NRC-03-031

KEWAUNEE NUCLEAR POWER PLANT
DOCKET 50-305
LICENSE No. DPR-43
LICENSE AMENDMENT REQUEST 187 TO THE KEWAUNEE NUCLEAR POWER PLANT
TECHNICAL SPECIFICATIONS (TAC NO. MB5718)

Enclosure-RAI Question 58 Response

Figure 58-1: Peak Cladding Temperature Comparison

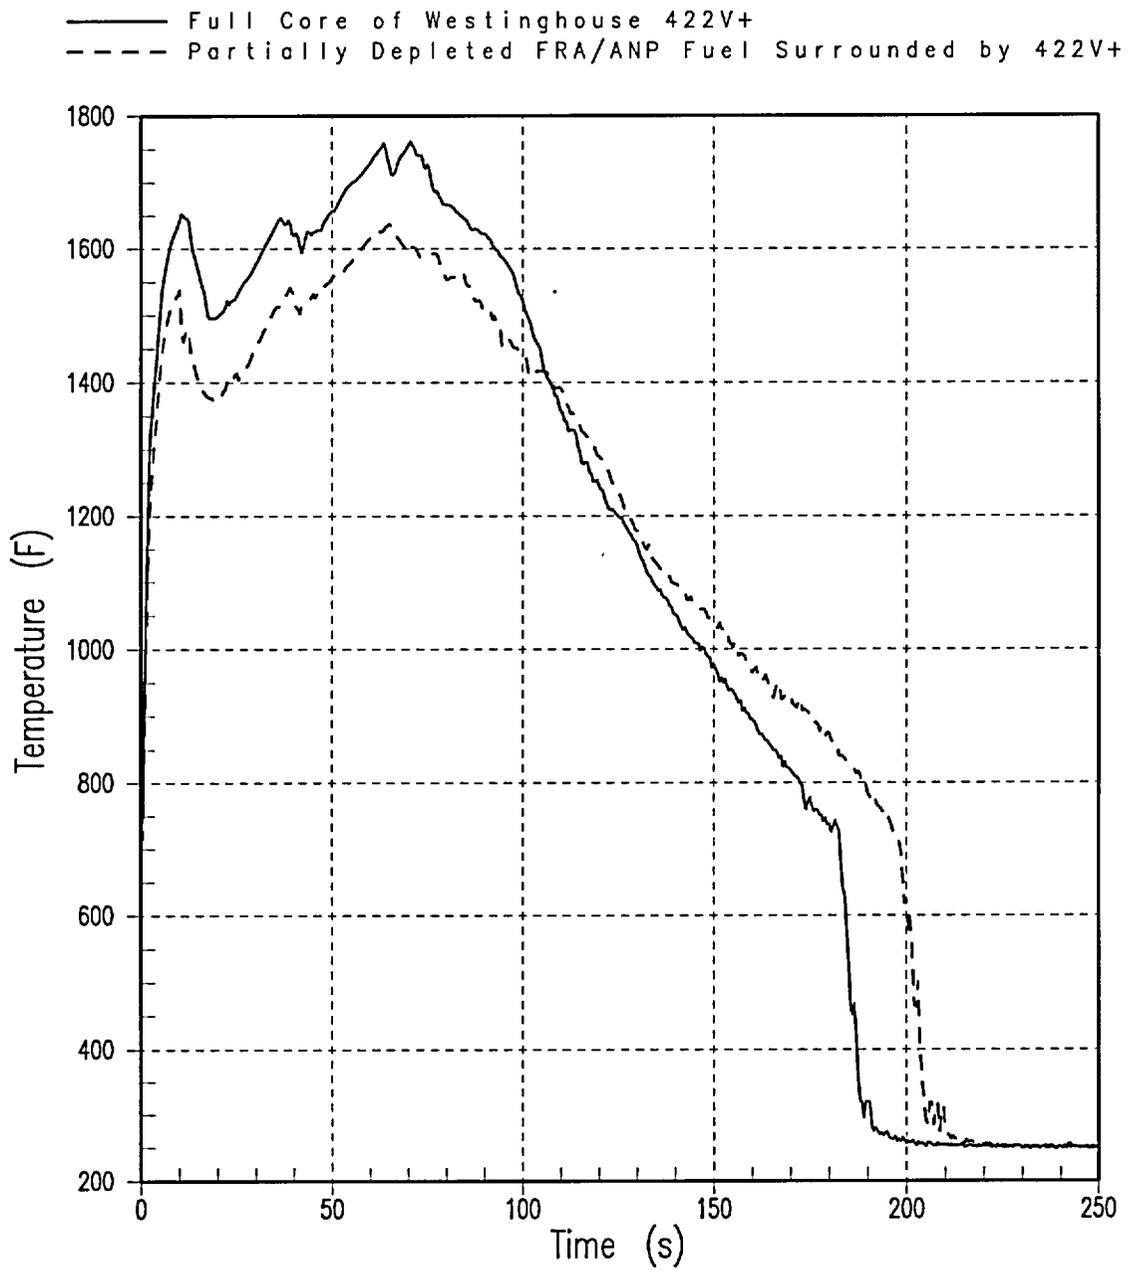
58. Because it is possible for one fuel type to be PCT-limiting, and another to be oxidation-limiting, provide a commitment to report LOCA analysis results for all fuel types (represented in a significant number of assemblies), per 10 CFR 50.46 (a)(3).

Figure 58-1 shows the PCT transients for a full core of 422V+ fuel compared to a transition core with partially depleted Framatome ANP fuel surrounded by 422V+ fuel. This calculation was performed using the reference transient conditions as defined by the Westinghouse methodology in WCAP-14449-P-A. Figures 58-2 and 58-3 compare the RCS pressure transients for those two runs, for the entire transient, and for the reflood portion, respectively. Figure 58-4 compares the hot assembly collapsed liquid level. It can be seen that the core configuration has little effect on the RCS pressure or hot assembly collapsed liquid level. The reflood PCTs from Figure 58-1 are 1763°F for the full core 422V+ fuel calculation, and 1638°F for the calculation with partially depleted Framatome ANP fuel surrounded by 422V+ fuel.
